LINCOLN PARK PLANNING COMMISSION

2121 Dix – Drive-Thru Restaurant

Site Plan Review

Applicant	Chester R. Stempien
Project	Drive-Thru Restaurant
Address	2121 Dix Highway, Lincoln Park, MI 48146
Date	July 13, 2022
Request	Site Plan Review

WEST ELEVATION

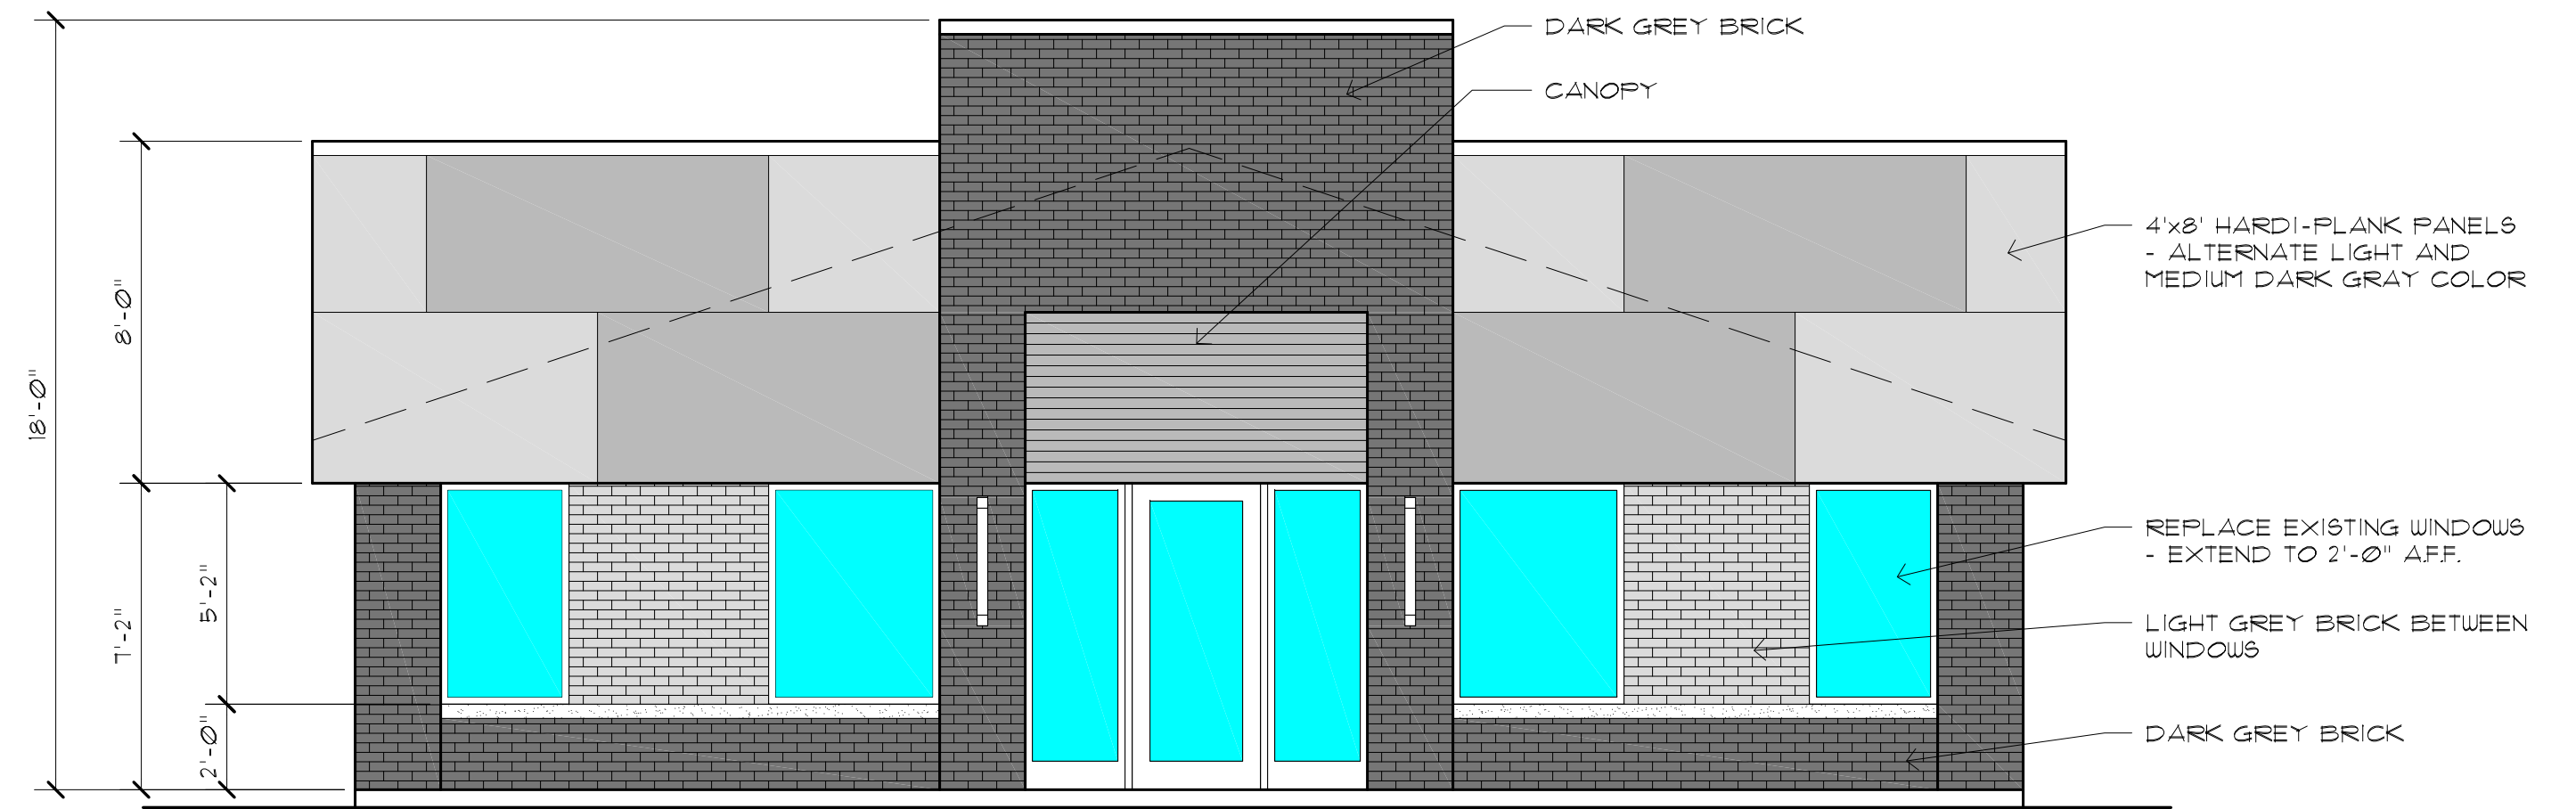
- Applicant shall provide details of materials used on the rear of the building (west elevation).
- Applicant shall redesign the building façades facing Dix Highway and White Avenue to comply with minimum 25% transparency requirement.

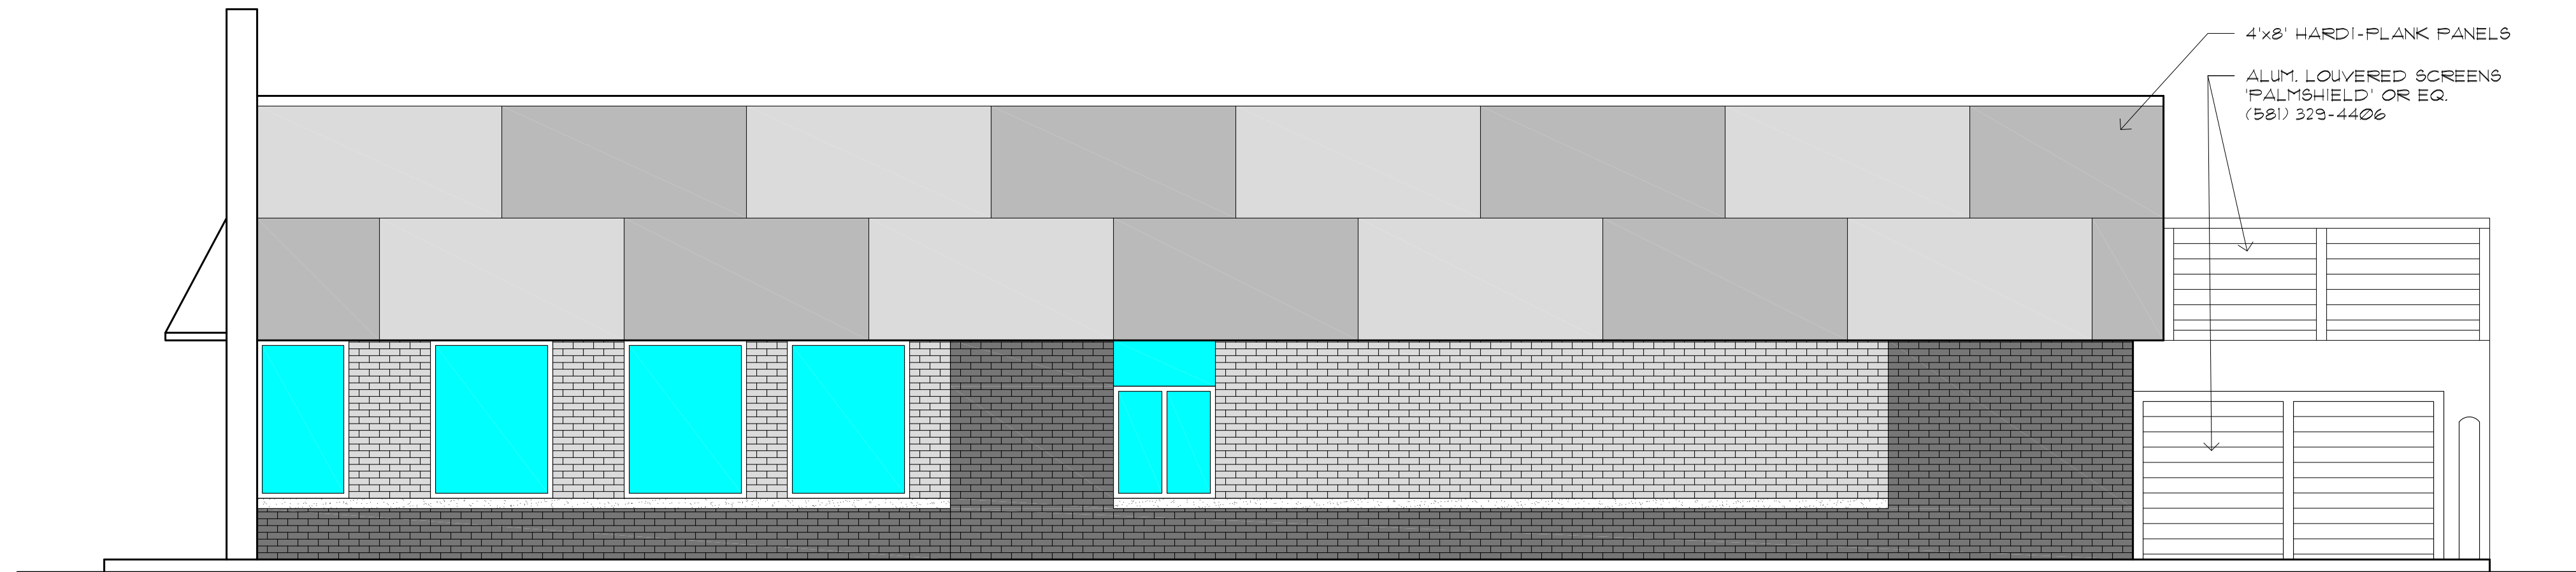
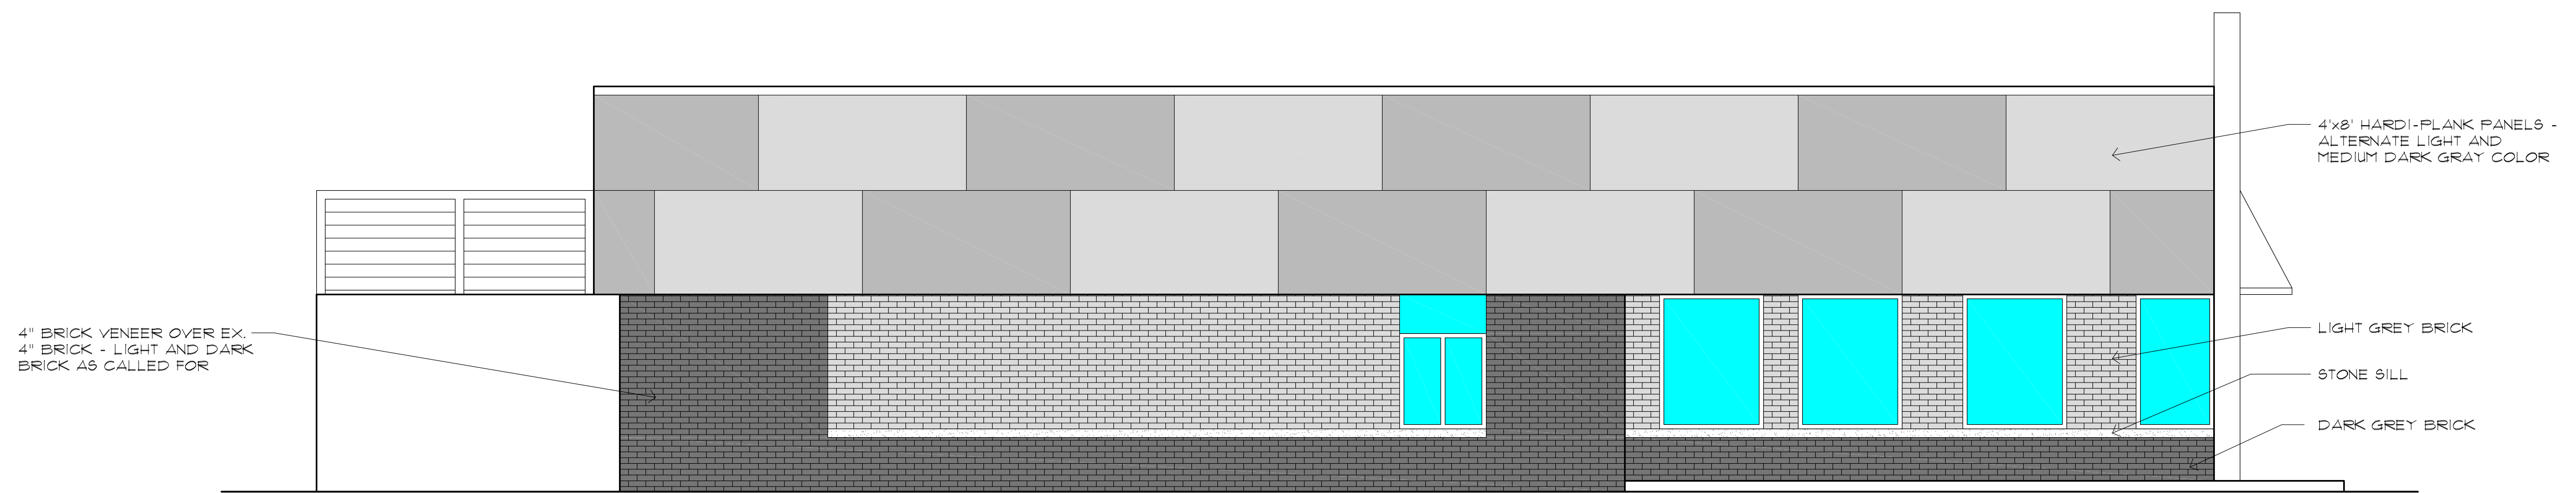
The proposed façade renovations include removing and replacing the windows on the existing building, painting the existing brick, and adding the hardi-plank panels on the upper portion of the building. Engineering comments indicate that some of the existing brick on the building will need to be repaired prior to occupancy. The proposed renovations will improve the existing building condition; however, the proposed square footage of windows does not meet the transparency requirements.

SUBJECT: SITE PLAN - LANDSCAPE

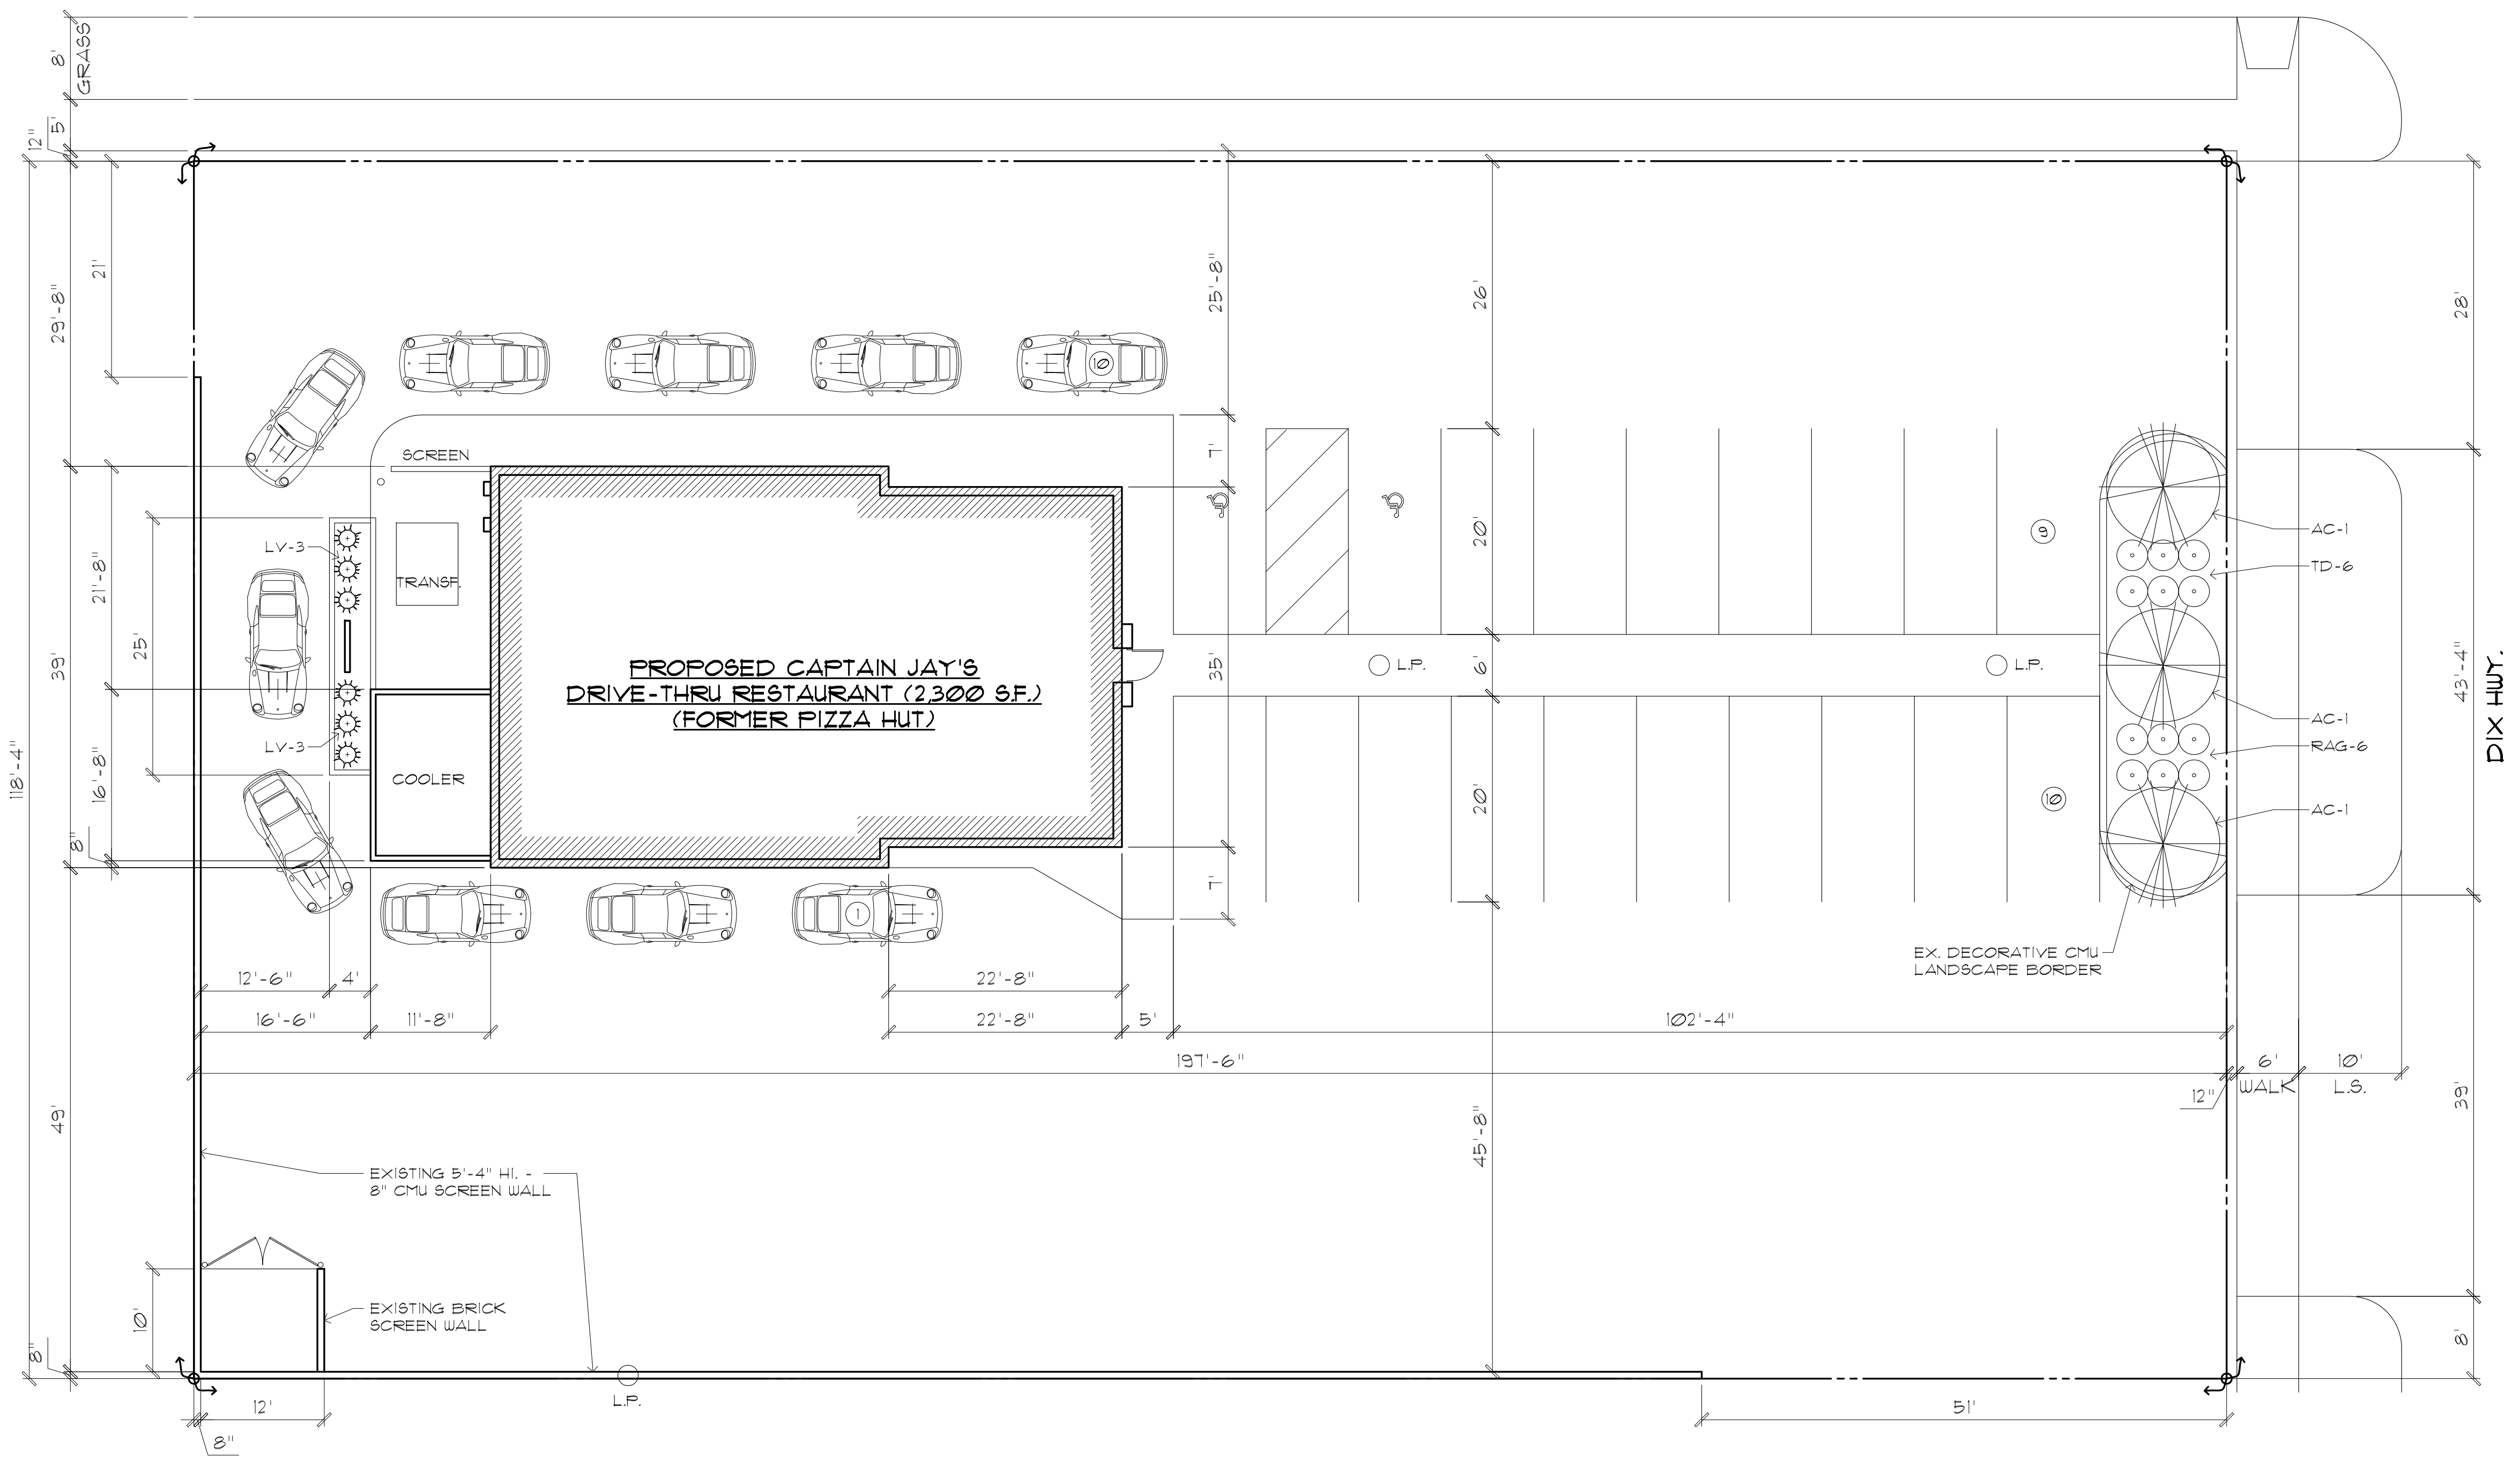
Because the proposed project is a redevelopment of an existing site, it must only meet 30% of the landscaping standards. There is space in the existing parking lot to create a landscape island to provide additional interior landscaping. Additionally, there is an existing 5' 4" masonry wall screening the site from adjacent residential properties. This wall shall be modified to meet the 6-ft. height standard.

- Applicant shall revise the landscaping plan to include 704 sf of interior landscaping.
- Applicant shall modify the existing solid masonry wall to meet the 6-ft. height requirement.
